### City of Eden Prairie – District 3 **10197 Eden Prairie Road Comprehensive Plan Amendment**

December 16, 2019

Community Development Committee

### **Amendment Details**

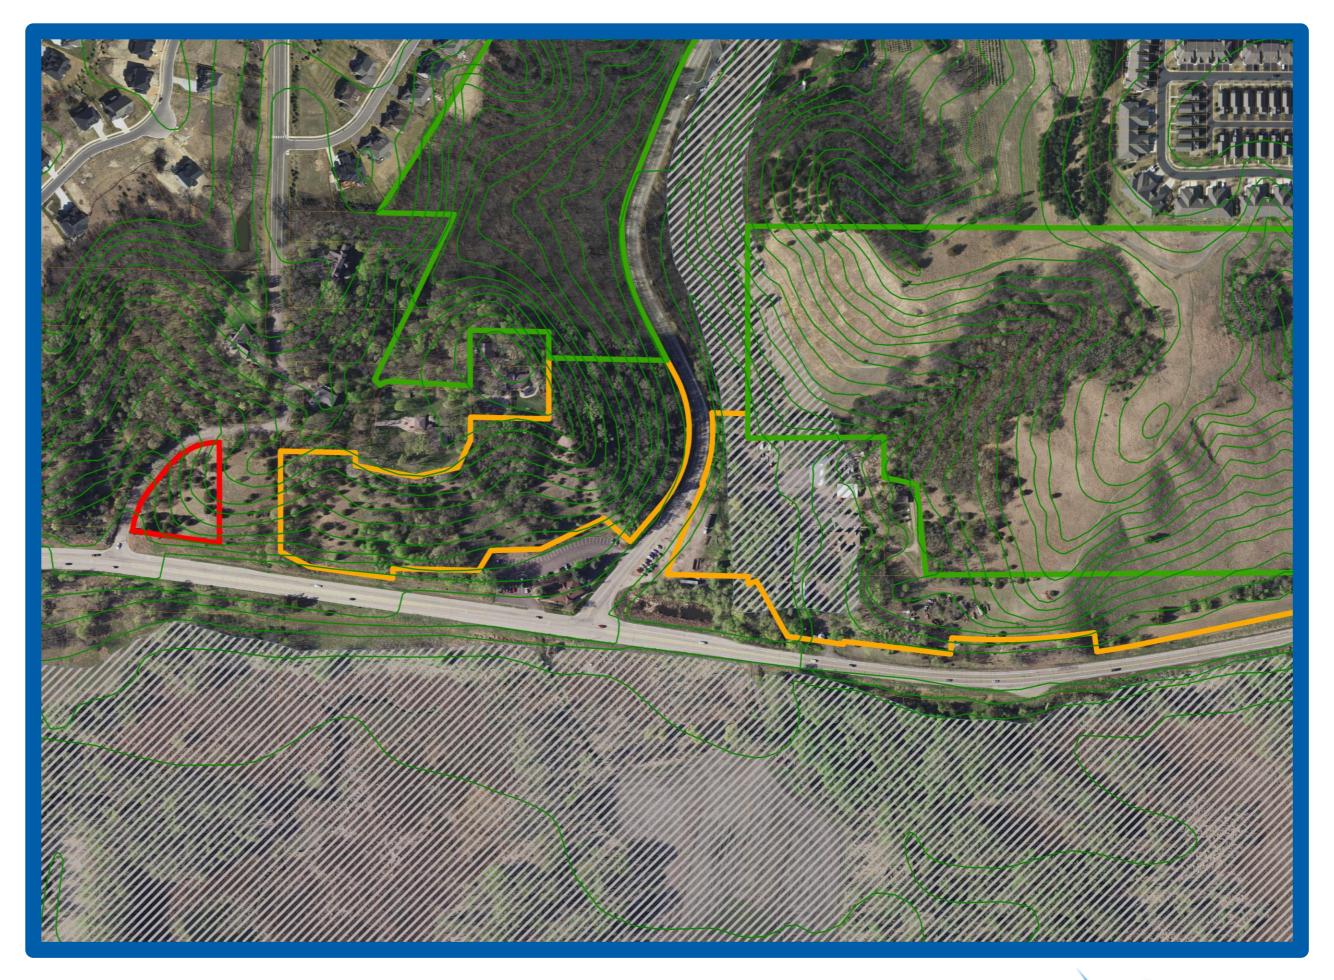
- Steep, erodible slopes
- High quality ecological area
- Adjacent to protected areas
